NOTICE OF DATA INACCURACY

INSPECTION REPORT

Electrical Corporation:	Southern California Edison Company
Report Number:	PAD_SCE_SIS_20261007_1026
Date of Inspection:	October 7, 2026
City and/or County of Inspection:	Yucaipa, San Bernardino County
Inspector:	Samuel Isaiah
WMP Year Inspected:	2026
Quarterly Data Report (QDR) Referenced:	Quarter 2 (Q2)
Inspection Selection:	Energy Safety viewed the contents of the Q2 QDR and performed an analysis that resulted in the selection of the WMP initiatives and locations referenced in this report.
Relevant WMP Initiative(s):	8.2.1.1 – WCCP Covered Conductor
Inspection Purpose:	Assess the accuracy of Southern California Edison Company's QDR data, completeness of its work, and performance of WMP requirements.

Exhibit A: Photo Log

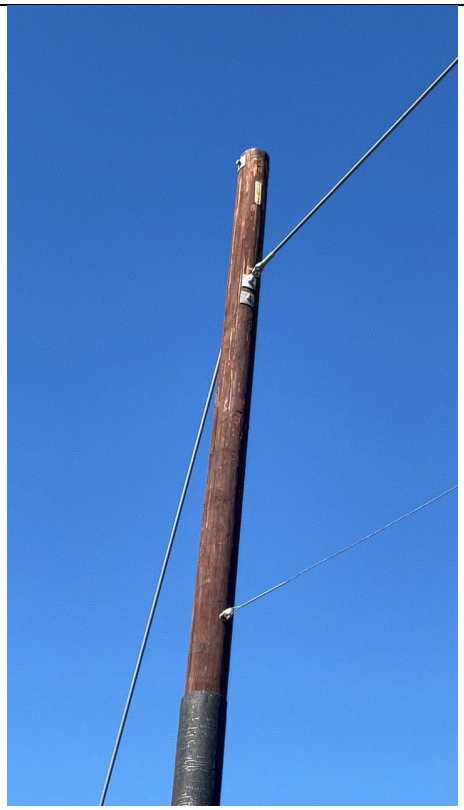
On Structure ID 5806823E, Grid Hardening ID TD2357977-5806823E at 12298 Fremont St, Yucaipa, CA, 92399, USA, coordinates 34.0299719993623, -117.026951999965, the inspector observed that SCE failed to provide accurate data on covered conductor installation initiative. The inspector's observation is documented in Data Inaccuracy 1 photographs, which are attached to this report as Exhibit A.

1. SCE reported in the 2026 Q2 QDR that work on WMP initiative 8.2.1.1 – WCCP Covered Conductor was completed at this location.
2. In 2024, SCE informed Energy Safety that stub pole work does not count toward Covered Conductor WMP totals and would either identify or exclude these points in future QDRs. This data point did not contain an identifier and was not excluded.
3. No covered conductor was observed.

This observation indicates that the data regarding covered conductor was not accurate. Failure to rectify this data inaccuracy prior to the submission of any performance assessments, such as annual reports, may result in a notice of non-performance.

Asset Image 1: No covered conductor observed	**Asset Image 2**: No covered conductor observed

Within 30 days from the issuance date of this NODI, SCE should provide a response advising Energy Safety of corrective actions taken or planned to remedy the identified data inaccuracy or inaccuracies.
